DATE OF ISSUE:
September 23, 2019

ADDENDUM NO. 01

PROJECT NO. CC0P 201901 – CARPET/FLOORING REPLACEMENT
ON THE 3RD, 4TH, AND 5TH FLOORS
OF THE PENNSYLVANIA JUDICIAL CENTER
HARRISBURG, DAUPHIN COUNTY, PENNSYLVANIA

VITETTA, 645 North 12th Street, Suite 100, Lemoyne, PA 17043

DRAWING A2.01

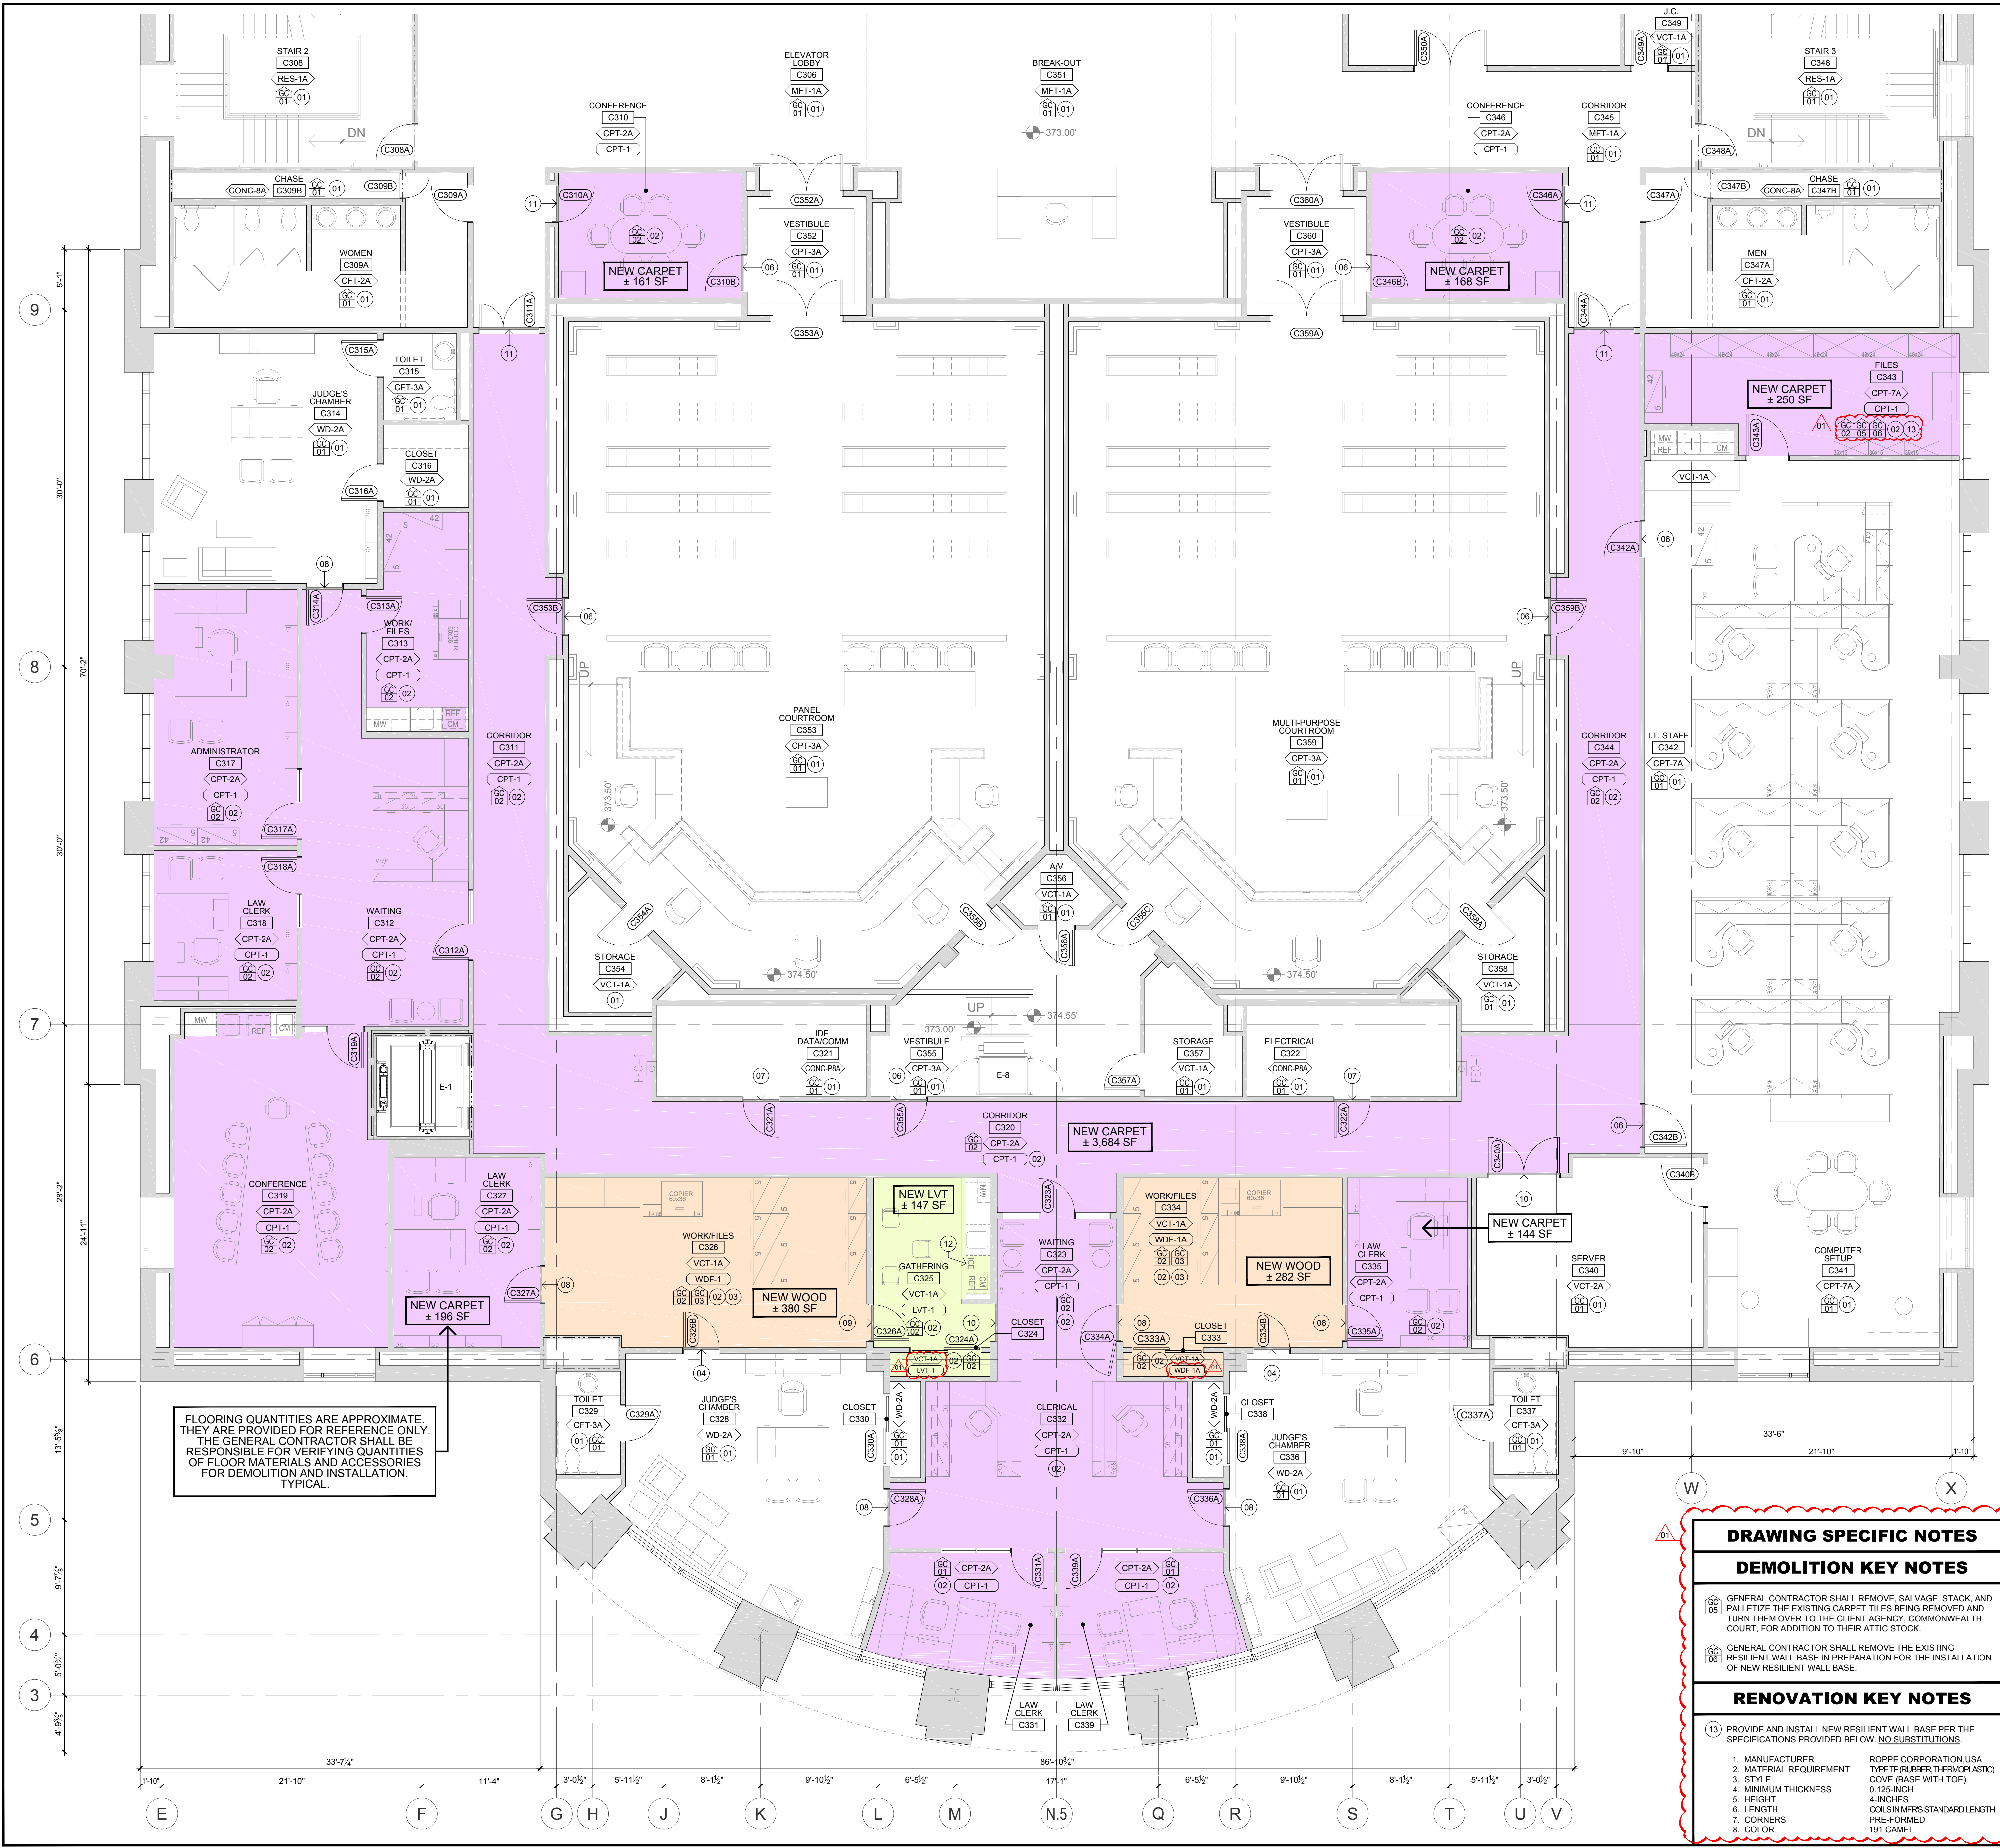
12. Revision 01, dated September 24, 2019: Added the following Drawing Specific Key Notes.
- a. Demolition Key Note GC-05: General Contractor shall remove, salvage, stack, and palletize the existing carpet tiles being removed and turn them over to the Client Agency, Commonwealth Court, for addition to their attic stock.
 - b. Demolition Key Note GC-06: General Contractor shall remove the existing resilient wall base in preparation for the installation of new resilient wall base.
 - c. Renovation Key Note 13: Provide and install new resilient wall base per the specifications provided below. NO SUBSTITUTIONS.

13. Revision 02, dated September 24, 2019: At Closet 324, corrected floor finish to LVT-1.
14. Revision 03, dated September 24, 2019: At Closet 333, corrected floor finish to WDF-1A.

GENERAL CONTRACTOR SHALL REMOVE, SALVAGE, STACK, AND PALLETIZE THE EXISTING CARPET TILES BEING REMOVED AND TURN THEM OVER TO THE CLIENT AGENCY, COMMONWEALTH COURT, FOR ADDITION TO THEIR ATTIC STOCK.

GENERAL CONTRACTOR SHALL REMOVE THE EXISTING RESILIENT WALL BASE IN PREPARATION FOR THE INSTALLATION OF NEW RESILIENT WALL BASE.

PROVIDE AND INSTALL NEW RESILIENT WALL BASE PER THE SPECIFICATIONS PROVIDED BELOW. NO SUBSTITUTIONS.
